MISSISSIPPI RIVER - GULF OUTLET  
LOUISIANA

DESIGN MEMORANDUM NO. 1-B

CHANNELS

COMMENTS ON DESIGN MEMORANDUM INCLOSED WITH LETTER, LMNGY,  
DATED 15 SEPTEMBER 1958, SUBJECT, "DESIGN MEMORANDUM NO. 1-B,  
CHANNELS, MISSISSIPPI RIVER - GULF OUTLET"

**SOIL DATA AND STABILITY ANALYSIS**

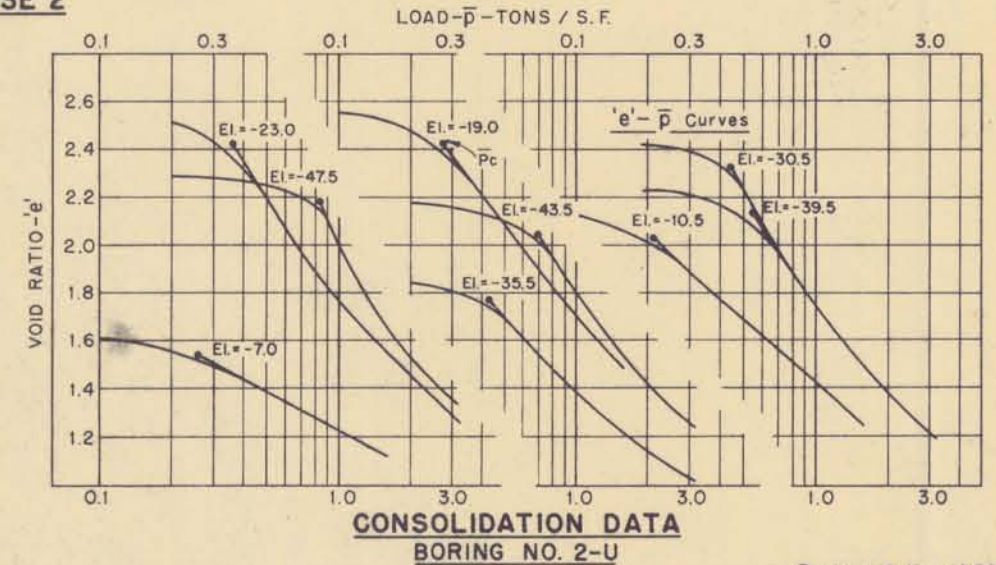
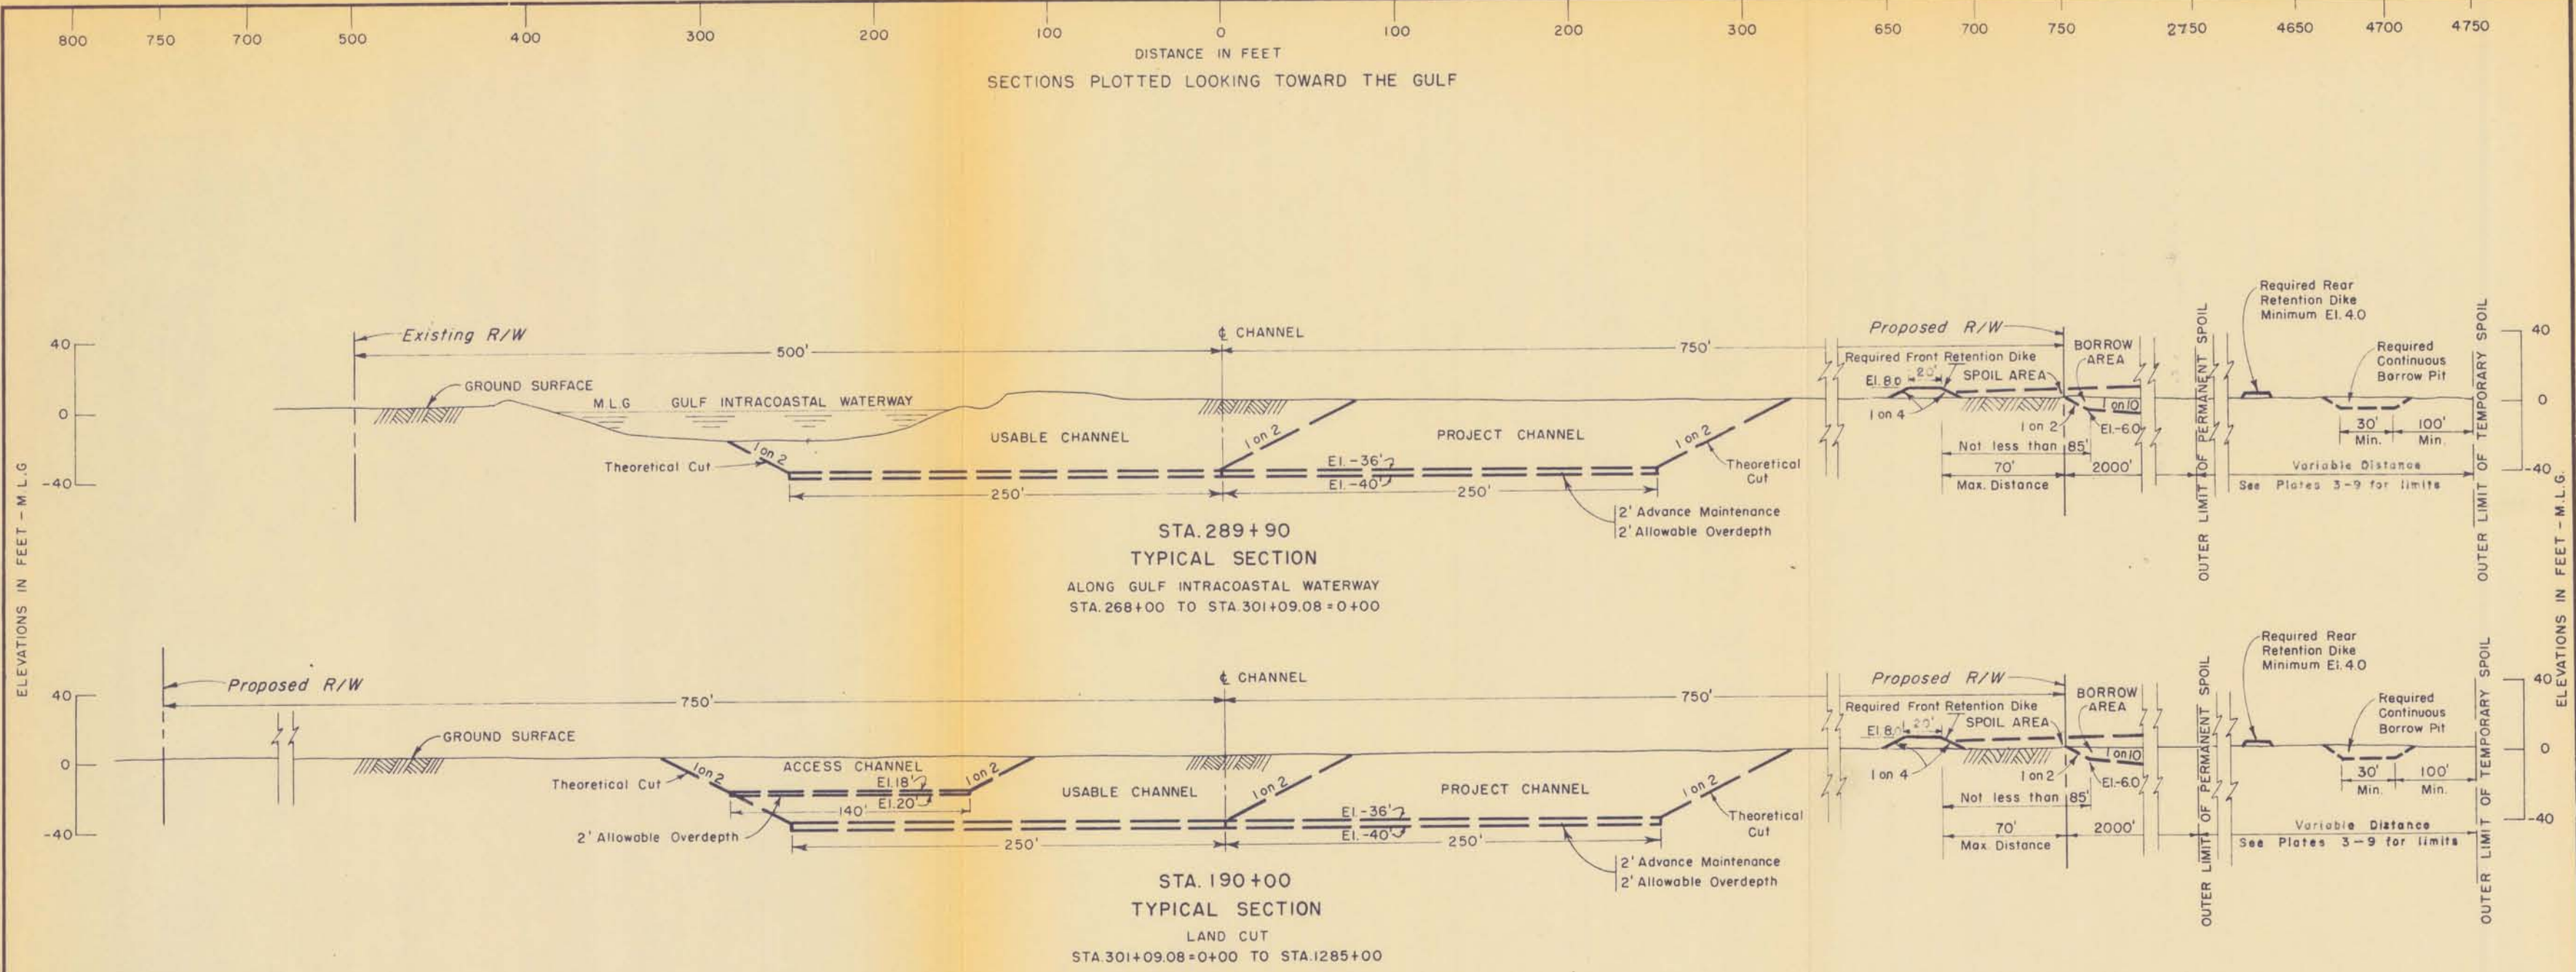
2. Par. 18, Page 5 and Plate 11.

a. Stability analyses on Plate 11 should be checked; the factors of safety are less than those shown. (The factor of safety of the over-all 1 on 2 channel slope is about unity instead of 1.22).

b. The toe of the spoil retaining dike should be plotted 90 ft. from the channel bank, instead of 140 ft. and critical arcs and/or planes and corresponding factors of safety should be shown for this case.

c. Assumed shear strength and unit weight of spoil should be added to Plate 11.

d. If each phase of channel is excavated as a box cut, channel slopes of about 1 on 2 probably will result during excavation since their factor of safety is about one. However, they may ultimately fail because the shear strength of the clay may decrease due to reduction of effective stress caused by excavation. Therefore, the stability of slopes should be checked based on CD shear test data to evaluate the long-term stability. If these analyses show flatter slopes required, consideration should be given to excavating the final flatter slopes by a series of step cuts to reduce maintenance dredging in lieu of making a box cut and then be confronted with possible considerable maintenance dredging.

\*The stability analysis is based on a minimum berm width of 90 feet and an elevation of 6 for the top of the dike. The berm width will be larger than 90 feet to provide for erosion due to wave wash and the initial section of the retention dike will be as shown on Plate 12.
